Index 102-665
Limited Access, Temporary Opening

COMMENTARY

COMMENTS AND RESPONSES

MOT-06-06

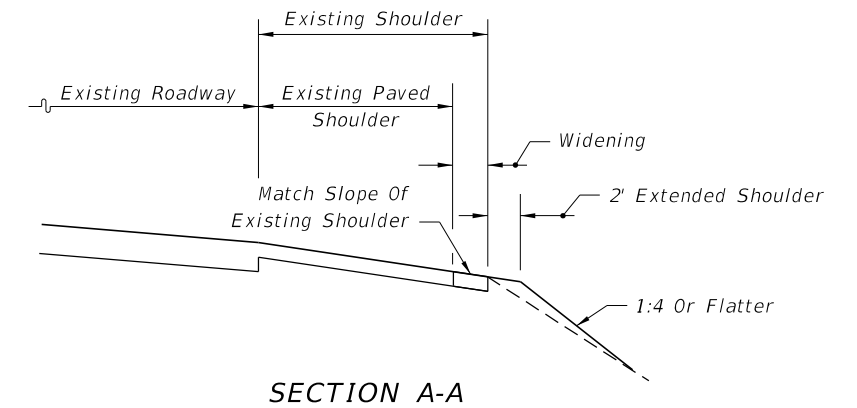
COMMENT: Sheet 1: Side Drain Pipe callout incorrect. Correct to "See Note 6"

RESPONSE: *Agreed*
Change Made: *Call-out corrected.*
